# Comments on “Improving Transferability Between Different Engineering Stages in the Development of Automated Material Flow Modules”

**Abstract**—In the paper by D. Regulin *et al.* (*IEEE Trans. On Automation Science and Engineering*, vol. 13, no. 4, 1422-1432, October 2016) authors claim that they present a meta-model for the modeling of the Automated Material Flow Module (aMFM) and a model-driven design approach for aMFMs. In this letter we comment on the presented meta-model and the proposed model-driven approach regarding their potential for exploitation. We present specific arguments and make cases that call the authors design decision into question.

Fig. 1. The AutoMFM [1, Ref.31, Fig.1].

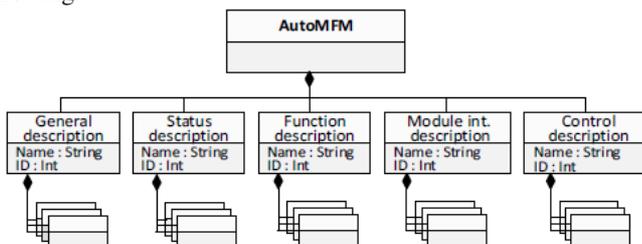
Authors do not refer the notation that is used to represent the model. The only reference to the modeling notation is given in the application example [1, Sec.V], where authors state that “The logistic functionality and behavior description of the T-junction was described in a Pert chart diagram.”

One may partition a complex system in various ways. For example, the procedural paradigm defines the function as the unit of partitioning, while the object-oriented defines the object. Authors define, through the AutoMFM, that the model of the aMFM is constituted from five parts that correspond to the (sub)classes of the AutoMFM, as shown in Fig. 1. Based on these parts, authors define the architecture of the module. However, authors do not argue on the reasoning of the proposed partitioning in terms of software and system engineering, not even present the benefits of such a partitioning. Moreover the proposed partitioning raises many questions that are discussed in the following.

The partitioning of the Control description module of the aMFM into control function and global variable list [1, Ref. 31, Fig. 3] is inconsistent with the claim that the proposed aMFM model captures the architecture of the aMFM.
